Access Compliance Report Public Rights-of-Way (Curb Ramps)

Main Street: CRAWFORD_CANYON_RD		Cross Street: N/A		Location:	NE
ADA ID: RPAT220225151044	Ramp Type:Type 1 - Perpendicular	Initial Pass/Fail: Pass	Overall Compliance: No	Severity Score:	5
Codes/Mitigation Info/Possible Solution			Field Measurements/Component Compliance

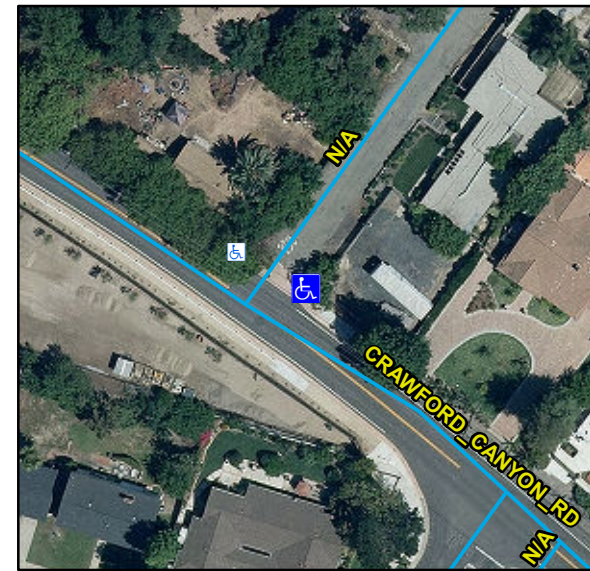
**Remove & Replace Detectable Warning System.
Utility Present.**

R305.1.4, STD 1115
